Access Compliance Report

Public Rights-of-Way

Intersection ID: 10661	Main Street: N_DAVIDSON_ST	Cross Street: E_28TH_ST	Location: S
ADA ID: 7D364BF30FB9	Ramp Type: BlendTrans1	Initial Pass/Fail: Fail	Overall Compliance: No
Severity Score: 10			
Codes/Mitigation Info/Possible Solution		Field Measurements/Component Compliance

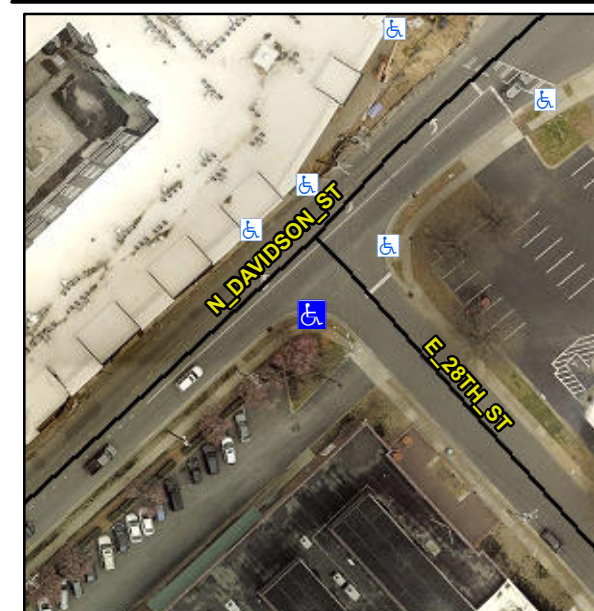
Not Found, R304.5.1, R304.5.3

Compliance	Description	Data	Compliance	Description	Data
N/A	Ramp Length (in)	47.5	Yes	BlendTrans Slope (%)	2.9
No	Ramp Width (in)	40.0	No	BlendTrans XSlope (%)	3.6
N/A	Flare Type LT	N/A	N/A	Flare Type RT	N/A
N/A	Flare Slope LT (%)	N/A	N/A	Flare Slope RT (%)	N/A
N/A	Flare Traversable LT?	N/A	N/A	Flare Traversable RT?	N/A
N/A	Landing Length (in)	N/A	N/A	DWS Provided?	N/A
N/A	Landing Width (in)	N/A	N/A	DWS Contrast?	N/A
N/A	Landing Slope (%)	N/A	N/A	DWS Length (in)	N/A
N/A	Landing X Slope (%)	N/A	N/A	DWS Full Width?	N/A
N/A	Landing Curb? (Y/N)	N/A	N/A	DWS Offset (in)	N/A
N/A	Shared Landing?	N/A			
N/A	Gutter Ponding?	N/A	N/A	Gutter Slope (%)	N/A
N/A	Gutter Lip Ht (in)	N/A	N/A	Gutter X Slope (%)	N/A
N/A	Painted X Walk1?	No	N/A	Painted X Walk2?	No
	X Walk 1 Direction	To NE		X Walk 2 Direction	To NW
	X Walk 1 Width (in)	N/A		X Walk 2 Width (in)	N/A
	X Walk 1 Slope (%)	5.7		X Walk 2 Slope (%)	1.0
	X Walk 1 X Slope (%)	2.5		X Walk 2 X Slope (%)	3.6

N/A	Ramp inside XWalk1?	N/A	N/A	Ramp inside XWalk2?	N/A
	Road Slope (%)	1.4		Clear Space?	N/A
	Road X Slope (%)	6.6	N/A	Clear Space to XWalk (in)	N/A
N/A	Any Obstructions?	N/A	N/A	Storm Grate/Utility Hazard?	N/A
	Obstruction Type			Storm Grate/Utility Type	
		N/A			N/A
			Yes	Surface Condition? (G/P)	Good
			No	Curb Slope (%)	15.7

Remove & Replace Curb Ramp With Two New Directional Ramps or Equivalent.
